GXW450X Firmware Release Notes

FIRMWARE VERSION 1.0.0.35

GXW4501/GXW4502/GXW4504

04/20/2020

Figure 1 - SS7 Data Channel Selection

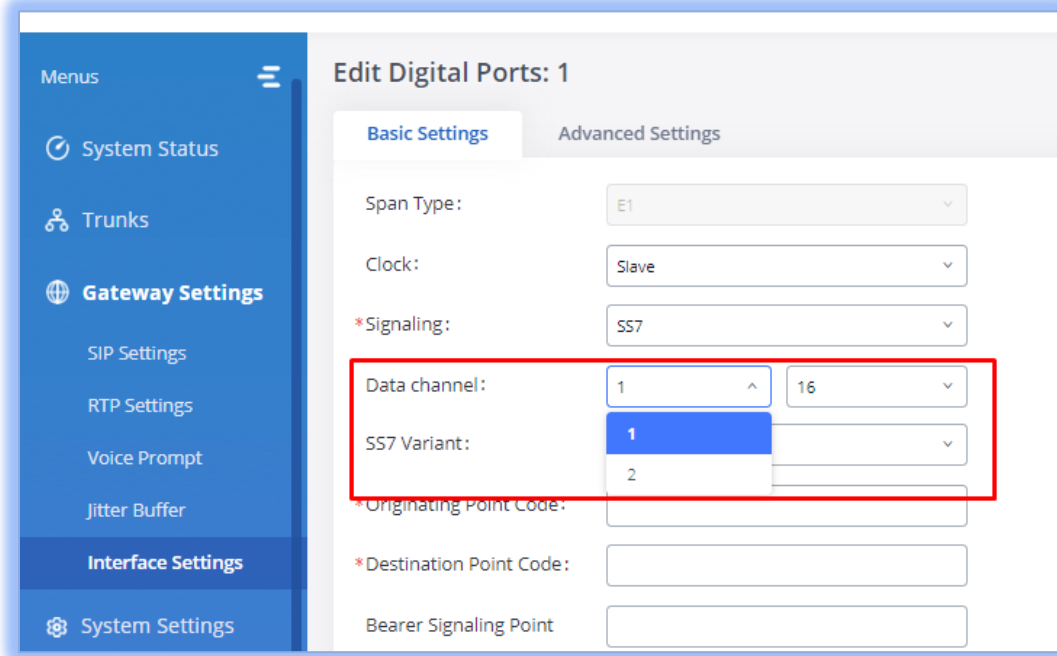
Users can now specify a different E1/T1 port to use for each port's data channel when SS7 is selected as the signaling type. The first dropdown list specifies the E1/T1 port to use. The second dropdown list specifies the channel to use for data connections.

Figure 2 - TLS Security

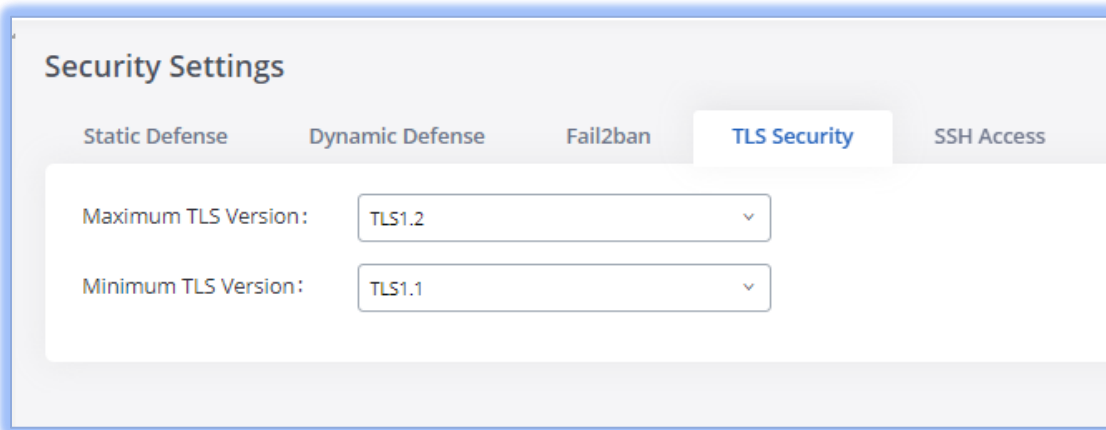
Users can now select the minimum and maximum versions of TLS for the GXW450x to support. The setting can be found under *System Settings* → *Security Settings* → *TLS Security* page.

Figure 3 - SNMP page

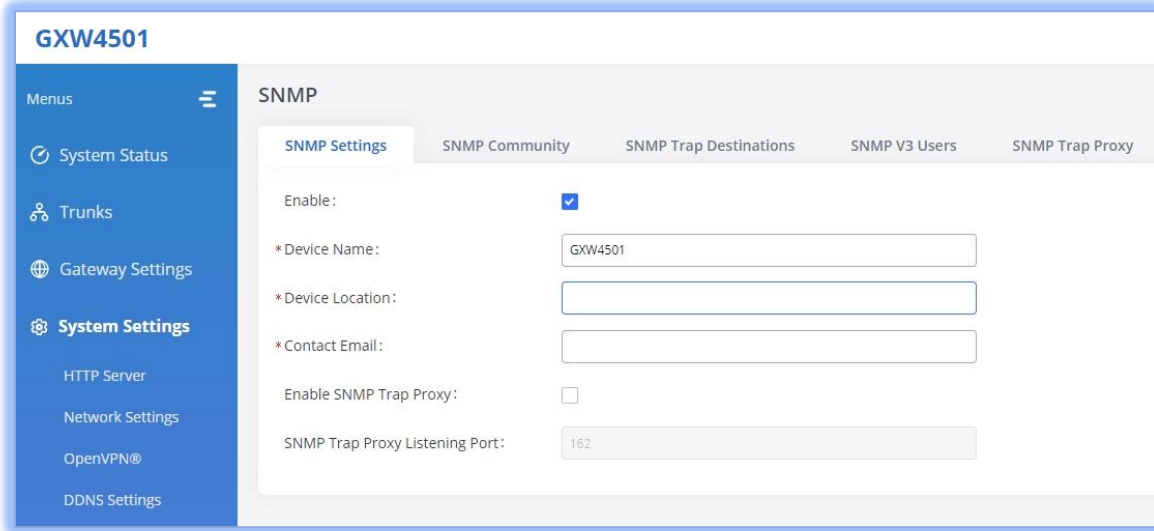
SNMP is now available and can be configured from *System Settings* → *SNMP*.

Figure 4 - SNMP Community

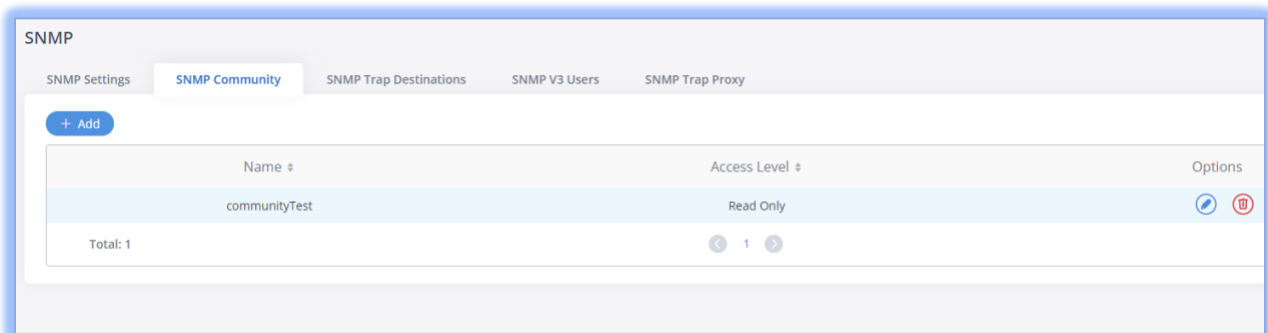
The SNMP Community page allows users to configure the GXW450x's community strings, allowing it to determine whether or not to respond to SNMP requests from clients. Two access levels are available: Read Only and Read/Write.

Figure 5 - SNMP Trap Destinations

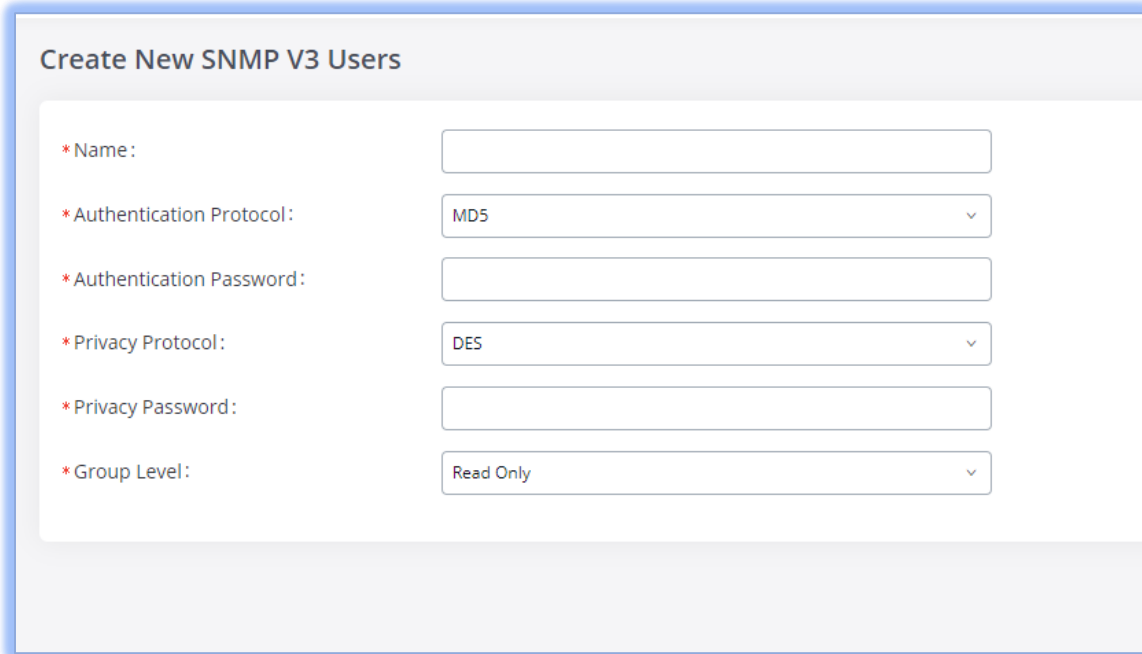
In the **SNMP Trap Destinations** page, users can point to where the device's traps should be sent to, set

the community string to use, and specify the type of notifications to send.

Figure 6 – SNMP v3 Users

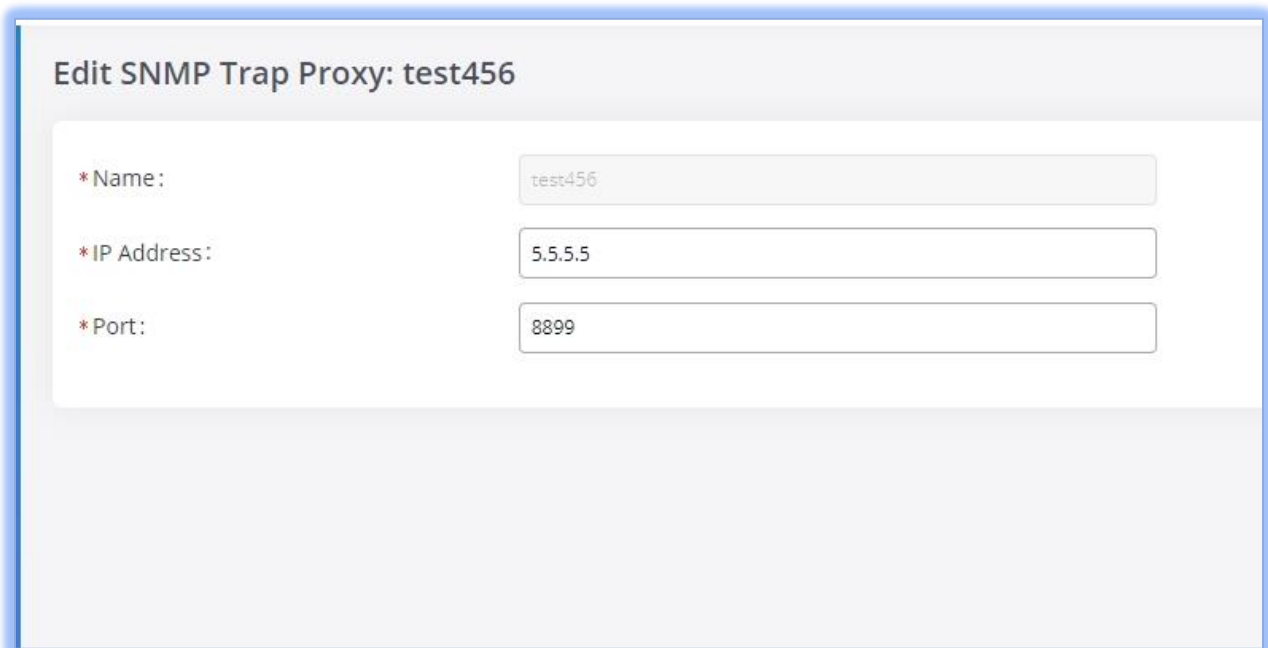
The **SNMP V3 Users** page will allow the configuration of SNMPv3 users for enhanced security.
